Date: January 14, 2022
To: Dago Garcia, P.E., City Engineer
Cc: Chris Kerr, AICP, Community Development Director
Roy Hankins, PE, Emerio Design
From: Colin Cortes, AICP, CNU-A, Senior Planner *CC*
Subject: **Planning Division review comments on civil engineering plans original submittal 2021 for Smith Creek Phase 3A (Tax Lot 052W130000105)**

Planning Division staff identifies revisions needed before sign-off on Public Works Department Engineering Division approval and issuance of civil engineering plans for Smith Creek Development Phase 3A, which is south of Phase 2A, along the east side of Stubb Rd NE, and north of the tributary of Mill Creek.

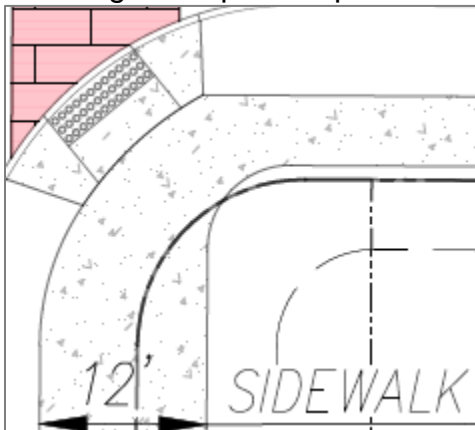
- D. Stubb/Sawtelle SE corner sidewalk taper: Revise Sheets 8, 31 "Curb Return Details", Detail 20, and 48 to fill in the unpaved triangular area next to sidewalk where the sidewalk transitions between 12 ft and 5 ft wide, resulting in something similar to the following concept excerpted from final order Exhibit C-11B Sheet 2 of 2 middle detail:

Substantial conformance (and not exact conformance) with Condition PUD-4d (p. 56) regarding taper is permissible.
